Service note

ACS 1000 auxiliary power upgrade

ACS 1000 variable speed drives; water cooled and air cooled

Old power supply concept

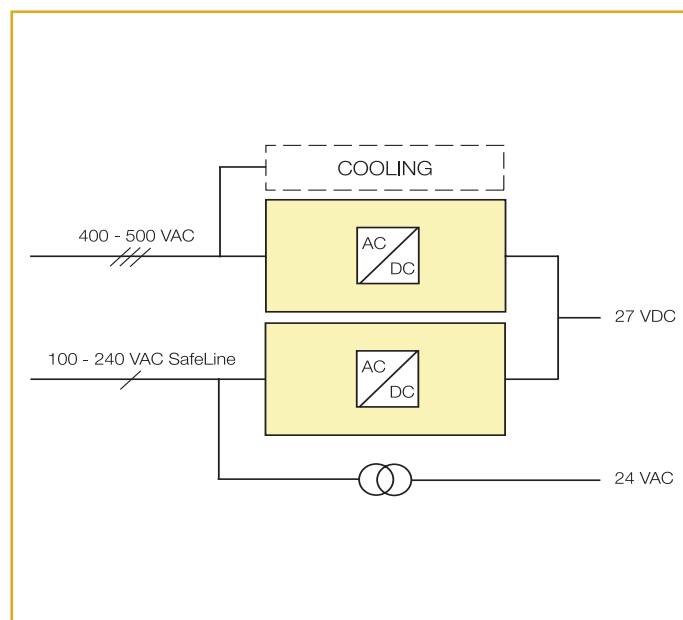
The probability of malfunction of electrical equipment does not only depend on the reliability of the equipment itself, but also on external factors, such as network conditions. In case of an auxiliary power loss, the ACS 1000 can cope with a power loss as the drive is equipped with back-up batteries. These batteries limit the "Power-Loss-Ride-Through" to one second. However, batteries have a limited life expectancy.

To overcome these constraints, a new auxiliary power concept without back-up batteries has been designed and is now available as a retrofit option.

In addition to the standard three phase auxiliary supply which is used also for cooling, the new power supply concept uses a safe line auxiliary source from the customer's UPS to supply the drive power supplies. This upgrade further improves the reliability and availability of the ACS 1000.

New power supply concept

Requirements:

- External 1 phase UPS supply (control) and external 3 phase supply (cooling)
- Approximately one working day needed for the upgrade on-site
- AMC33/AMC34 with software version MSOH4100 or newer
- EPLD version MSEE5110 or newer
